**Tree Inventory, Assessment,
and
Protection Report**

**APN 510-47-045
145 Wood Road
Los Gatos, CA 95032**

Town of Los Gatos

March 22, 2021

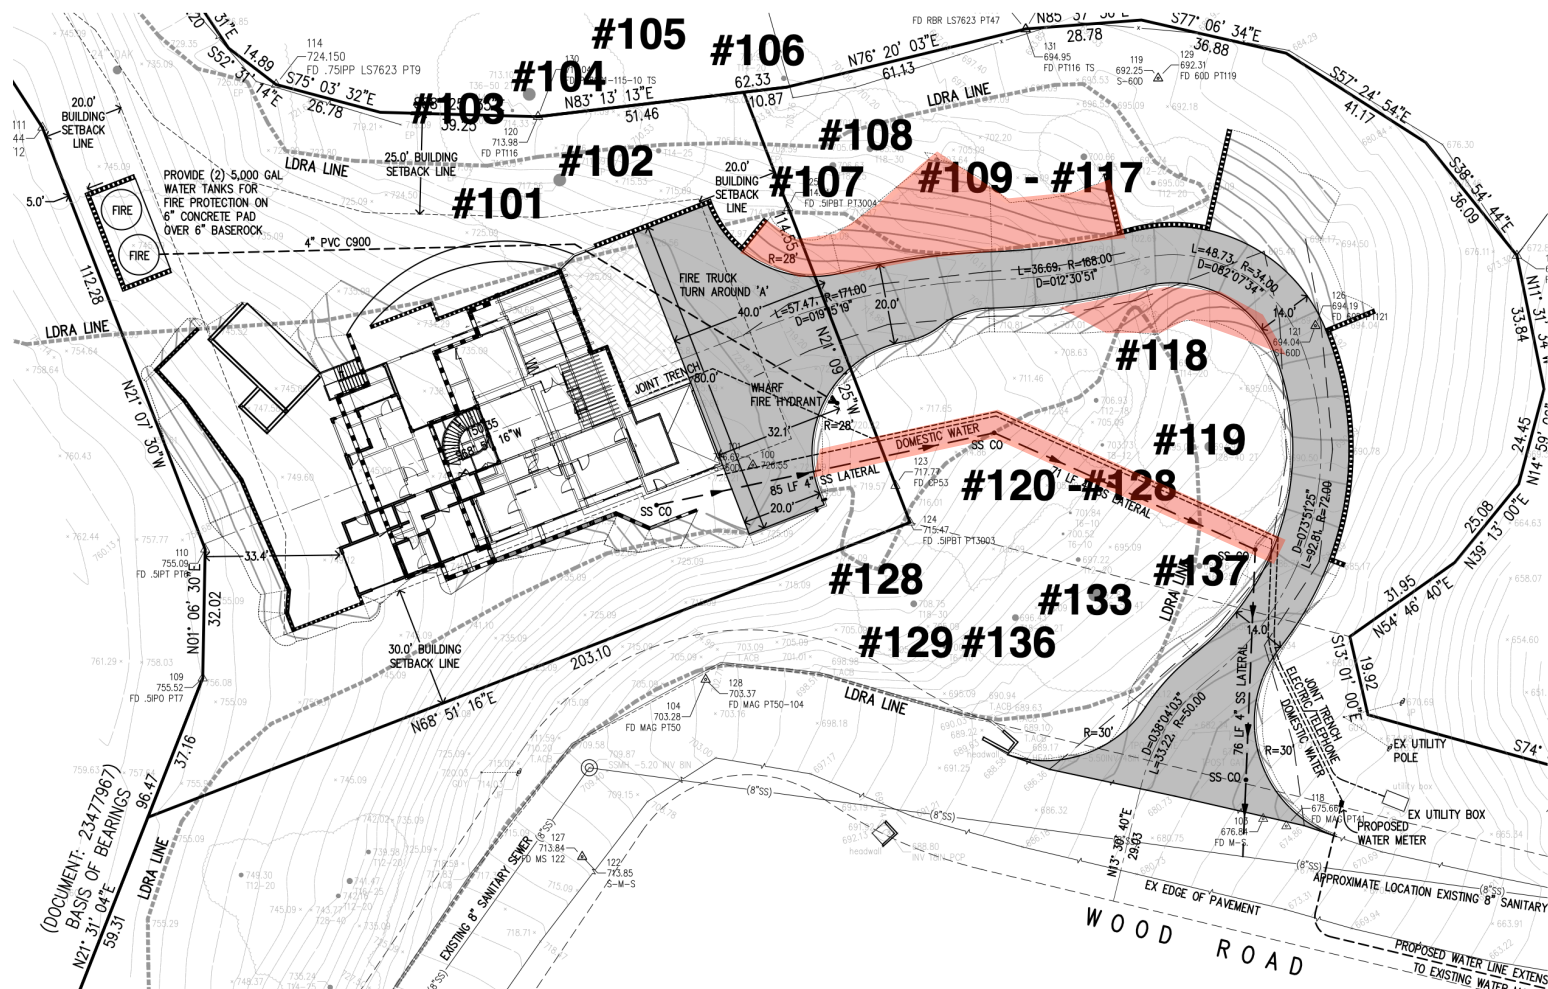
Ten trees could be moderate to highly impacted primarily from the proposed retaining wall near #115 - #117, driveway grading near #118, and the water and sanitary sewer bisecting the lower stand near trees #120 through #128.

The plan below indicates the area of expected impacts (Image 1). Highlighted in red are the areas where modifications could alleviate some issues. Running the water and sanitary sewer under the driveway or directly down the slope adjacent to valley oak #128 would remove the utility issues. The retaining wall and grading around #109-#117 would need to be altered.

2. Consider relocating the utilities to an area that does not bisect the southern grove of trees, possibly follow the driveway.
3. Consider adjusting the grading at the driveway radius to avoid the tree on both sides.
